Field Notes Bulletin

P/N FN00063

EST4: Functional Changes Between 4-SxDC/4-SDC and 3-SxDC2/3-SDC1 Signature Controller Modules

Figure 1: Attention label

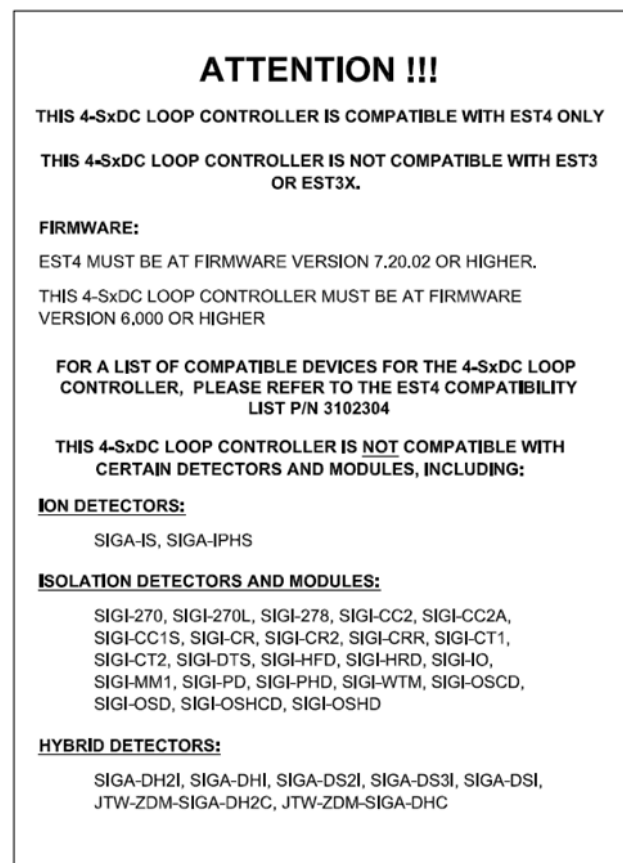
Each controller module ships with an Attention label (Figure 1) that shows the differences between legacy controller modules and the new 4-SxDC controller modules. The differences need consideration when migrating an EST3 system to an EST4 system or where a new controller module is used to service an EST4 system containing legacy controller modules.

Please review the Attention label for important compatibility information and firmware support.

3. Are the hybrid type devices listed in Figure 1 Attention Label on page 2 supported by the new 4-SxDC controller modules?

- The 4-SxDC controller modules do not yet support hybrid type devices listed on the Attention Label. If a hybrid type device is configured and installed on a 4-SxDC loop, a Compatible Fault trouble will be generated. Mapping Enabled and Mapping Disabled modes for the 4-SxDC function the same way in all markets. Note that this functionality is different than legacy controller modules in international and China markets, where the Mapping Disabled mode is allowed for SIGA and hybrid device swapping by physically programming a device with the expected device address.
- Support for hybrid devices (see Figure 1) will be added in a future version of 4-SxDC.

Note: EST4 will continue to support hybrid type devices on the legacy Signature controller modules 3-SxDC1 and 3-SxDC2.
